SUBJECT: Response to Conservation Halton Review of 7th EIR/FSS Submission - 3269 and 3271 Dundas Street West
Comments (January 22, 2021)

SUBJECT: Response to Conservation Halton Review of 7th EIR/FSS Submission - 3269 and 3271 Dundas Street West
Region of Halton Comments (January 13, 2021)

SUBJECT: Response to Region of Halton Transportation Comments (January 13, 2021 and April 19, 2021) - 3269 and 3271 Dundas Street West

407 WEST EMPLOYEMENT AREA, LAZY PAT FARMS TRAFFIC IMPACT STUDY - RESPONSE TO COMMENTS

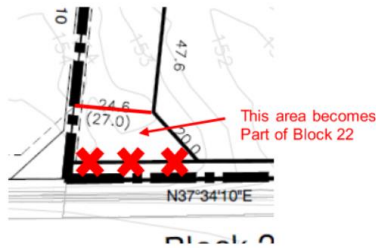
Any lands within 25 metres of the centre line of the original right-of-way of Dundas Street (Regional Road 5) that are part of the subject property shall be gratuitously dedicated to the Regional Municipality of Halton for the purpose of road right-of-way widening and future road improvements. The applicant is to provide confirmation that the proposed widening blocks on the plan would achieve the Region's road widening requirements (including those set out in the Dundas Street EA and as part of the Dundas Street widening project).

A figure is provided in Appendix C, which shows that the property line is 27m from the centre line of the original right-of-way of Dundas Street (Regional Road 5). The proposed road widening for Dundas Street as provided by the Region is shown as the proposed property line for the subject property.

The property line is beyond the 25 m from the centre line of the original right-of-way of Dundas Street (Regional Road 5). Therefore, the proposed property line achieves the Region's road widening requirements – the Dundas Street EA requirements and the Official Plan / Transportation Master Plan requirements.

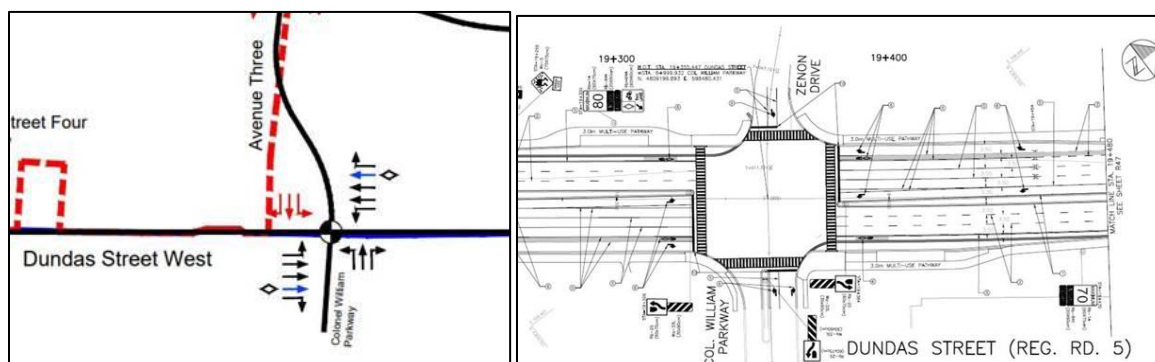
The proposed lane configurations at Avenue Three do not match what has been proposed in the Transportation Impact Study. The throat for the north leg of the intersection will accommodate a through-right / left configuration and one NB lane. To match the Transportation Impact Study proposed configuration, we will have to add an additional SB lane at the north leg of the intersection to provide the right / through / left configuration. The available property seems to accommodate the extra SB Lane; however, there may be impacts on the bus bay at this location.

WSP acknowledges Stantec's comment and recommends that the proposed configuration of the north leg from the TIS be implemented through the Dundas Street widening Phase 2 contract.

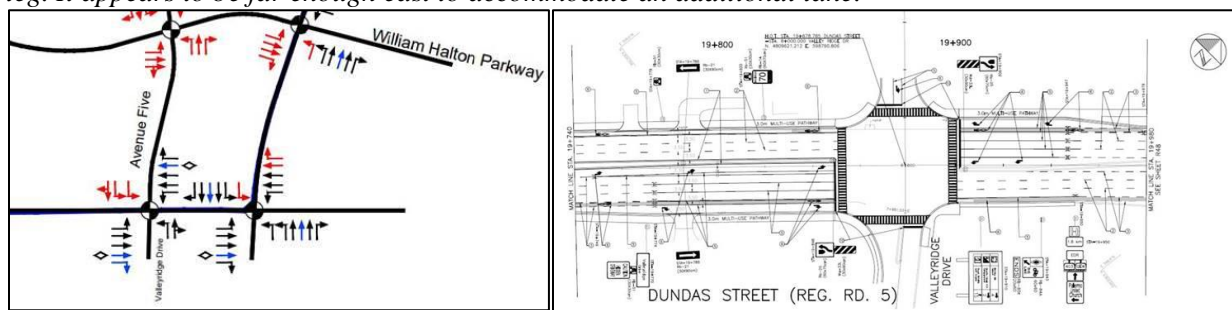
The proposed lane configurations at Avenue Five do not match what has been proposed in the Transportation Impact Study. The throat for the north leg of the intersection will accommodate a through-right / left configuration and one NB lane. To match the Transportation Impact Study proposed configuration, we will have to add an additional SB lane at the north leg of the intersection to provide the through-right / left / left configuration. Impacts on the 3111 Dundas should be manageable if an additional SB lane is added to the north leg. It appears to be far enough east to accommodate an additional lane.

WSP acknowledges Stantec's comment and recommends that the proposed configuration of the north leg from the TIS be implemented through the Dundas Street widening Phase 2 contract.

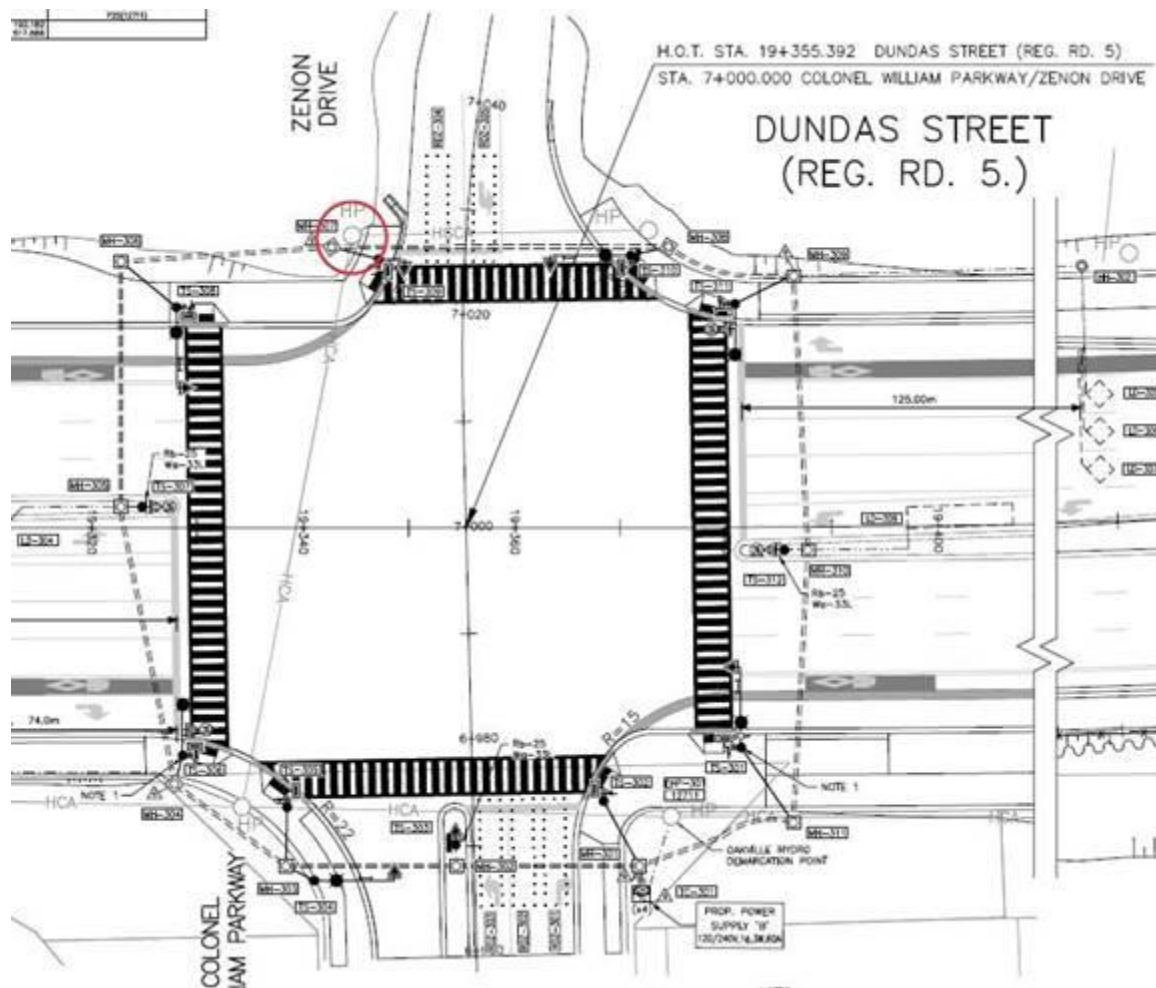
If we need to accommodate the differences in north leg lane configuration noted in the above Road Design comments, we will need to revisit and update the electrical design for traffic signals and illumination to match the geometric changes to ensure that the pole and associated underground structures are in the correct location. The temporary traffic signal layouts will need to be reviewed to confirm that the temporary pole location locations can accommodate any geometric changes required to the north approach legs at these three intersections.

The traffic signals at the new Street 'A' intersection will need to be coordinated with the signals at the Dundas Street / Tremaine Road intersection.

WSP acknowledges these comments that the electrical design for traffic signals and illumination will need to be revised to match the intersection configurations recommended in the TIS and that the traffic signals at the new Street 'A' intersection will need to be coordinated with the signals at the Dundas Street / Tremaine Road intersection.

The proposed lane configurations at the Avenue Two intersection are as follows:

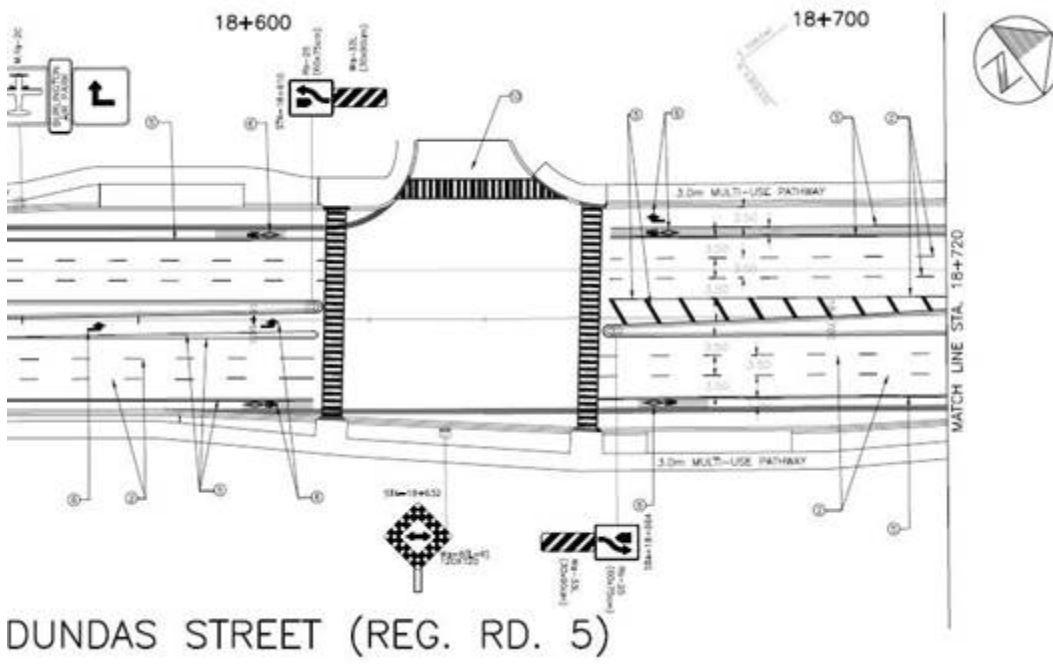
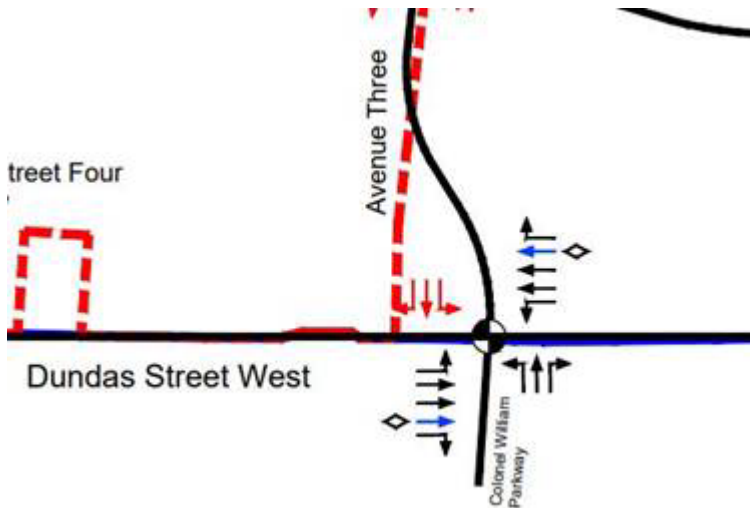
The proposed lane configurations at Avenue Two do not match what has been proposed in the Transportation Impact Study. The throat for the north leg of the intersection will not accommodate the proposed right / right-left / left configuration and one NB lane. To match the Transportation Impact Study proposed configuration, we will have to add an additional SB lane at the north leg of the intersection to provide the right / right-left / left configuration. There may be additional property required to add a south bound turn lane. The west side of the north leg is quite close to the property line that we have on our property plans. If we can shift the north leg it may be able to accommodate the additional south bound lane.

The proposed lane configurations at the Avenue Three (Zenon Drive) intersection are as follows:

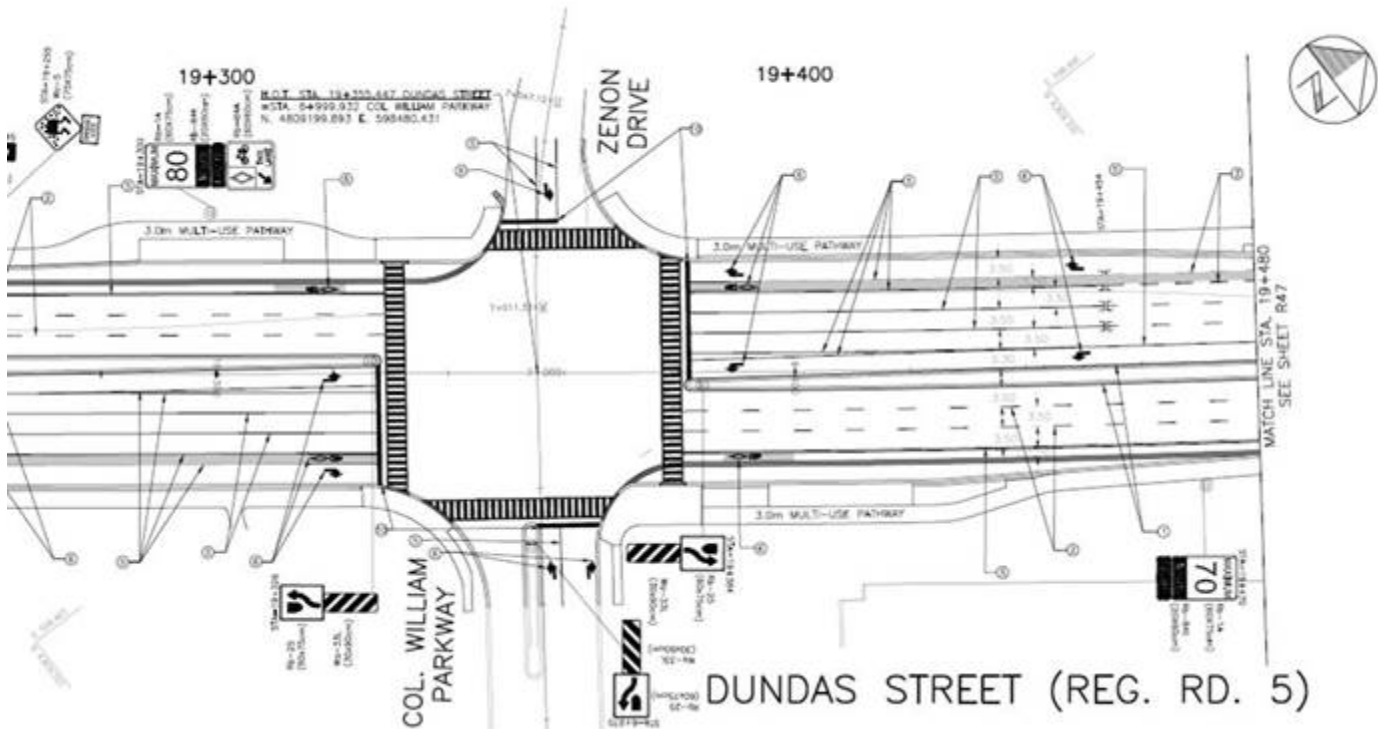
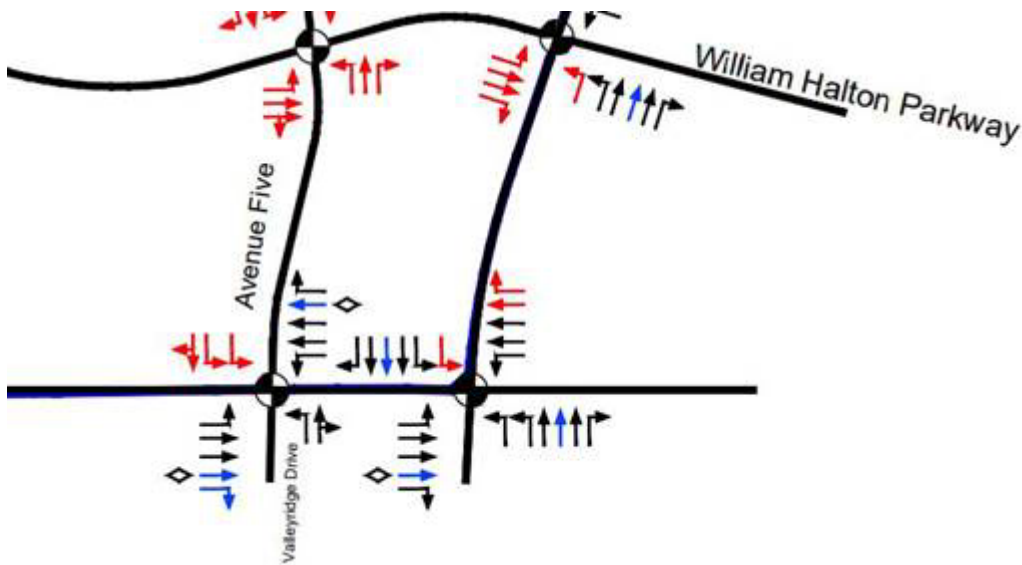
The proposed lane configurations at Avenue Three do not match what has been proposed in the Transportation Impact Study. The throat for the north leg of the intersection will accommodate a through-right / left configuration and one NB lane. To match the Transportation Impact Study proposed configuration, we will have to add an additional SB lane at the north leg of the intersection to provide the right / through / left configuration. The available property seems to accommodate the extra SB Lane; however, there may be impacts on the bus bay at this location.

The proposed lane configurations at the Avenue Five intersection are as follows:

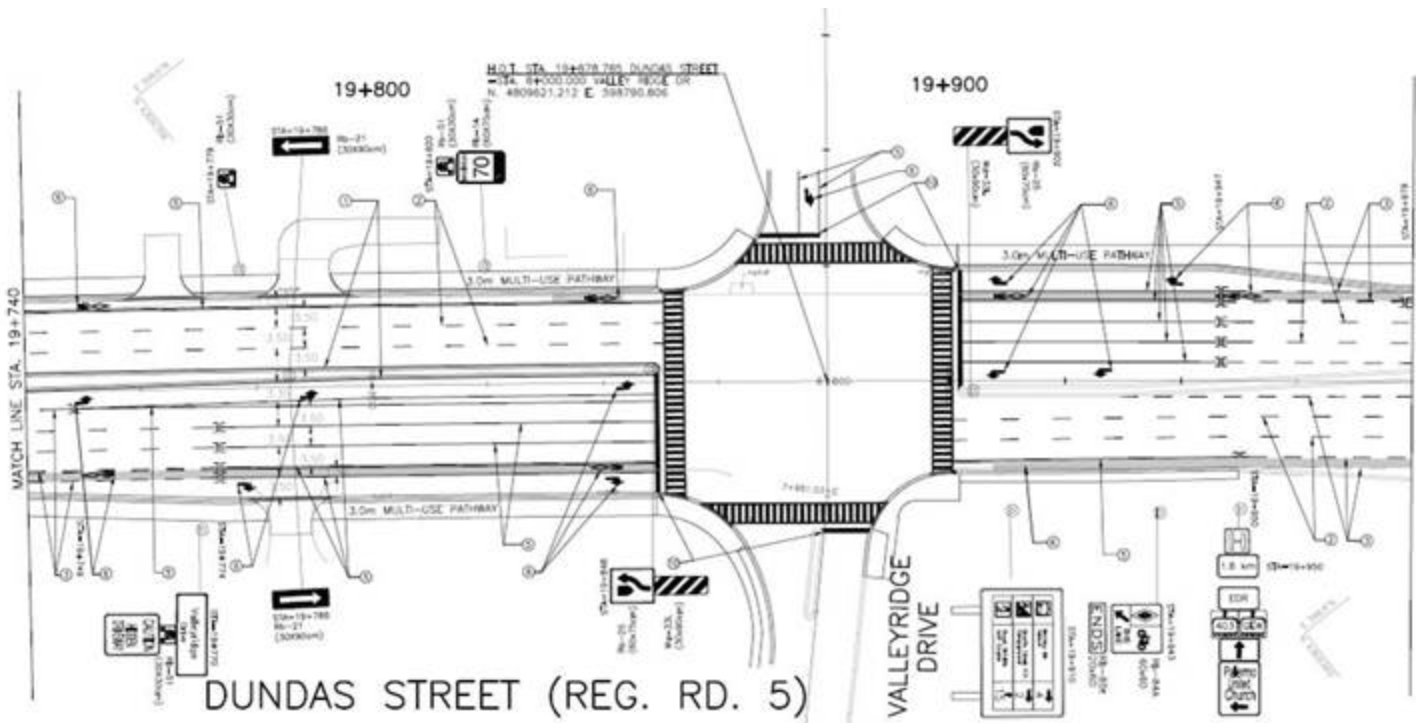
The proposed lane configurations at Avenue Five do not match what has been proposed in the Transportation Impact Study. The throat for the north leg of the intersection will accommodate a through-right / left configuration and one NB lane. To match the Transportation Impact Study proposed configuration, we will have to add an additional SB lane at the north leg of the intersection to provide the through-right / left / left configuration. Impacts on the 3111 Dundas should be manageable if an additional SB lane is added to the north leg. It appears to be far enough east to accommodate an additional lane.

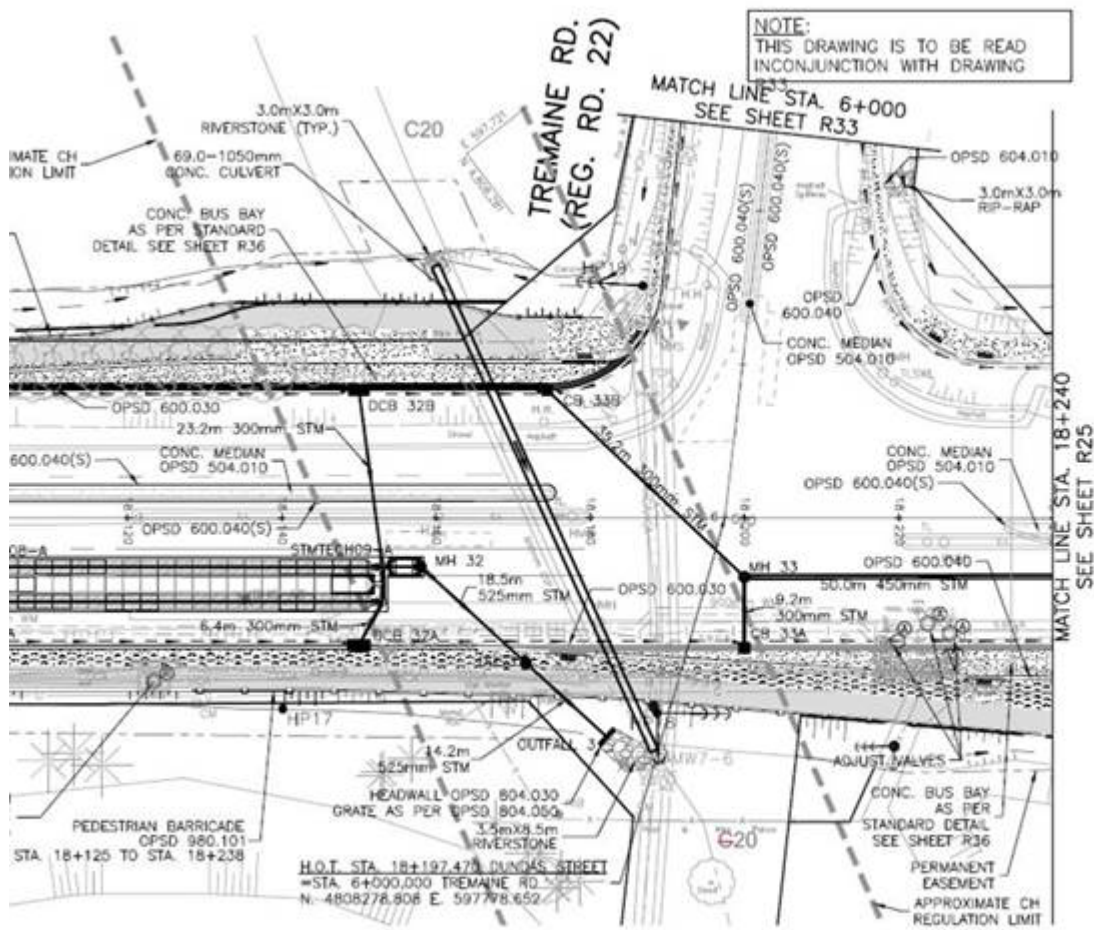
The implementation of a channelized right turn movement at Tremaine Road would have implications to the current design plan (please see excerpts from the current new construction and pavement marking/signing plans for reference). Shifting and widening the alignment of the NW intersection radius to the west to accommodate a channelized refuge island would also shift the bus bay and realigned culvert C20 to the west and the addition of a WB receiving lane would shift these elements to the north including a longer Culvert C20. This may also trigger additional and/or revised permits from CH. Additional property would be required from the Evergreen development in the NW quadrant to allow for the incorporation of a channelized refuge island if the current horizontal alignment of Tremaine Road is maintained. There

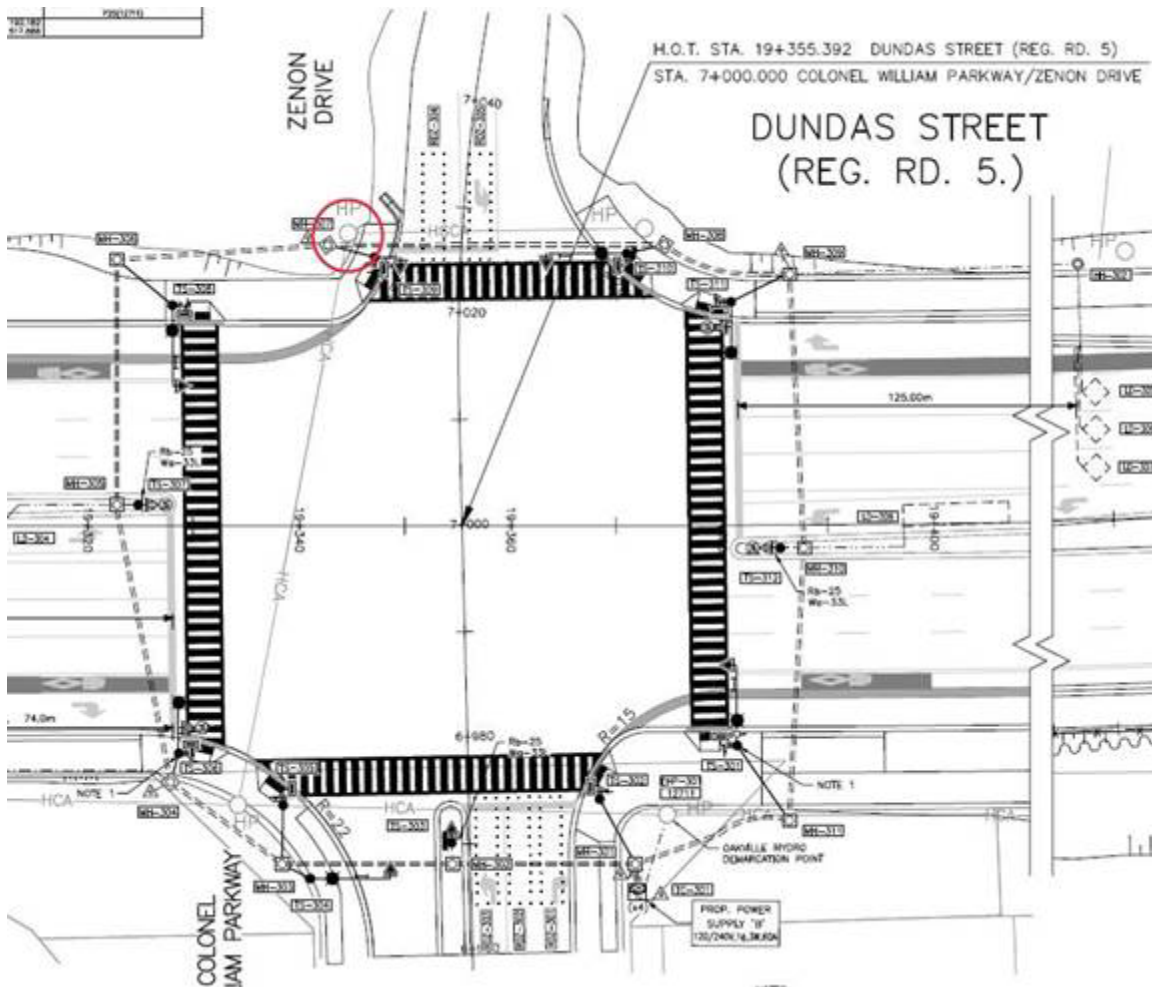
At Avenue Three, the traffic signal design includes the full layout since Zenon Drive is currently an active roadway north of Dundas Street West. If we need to accommodate three SB lanes at the north approach leg, the electrical design will need to be updated.
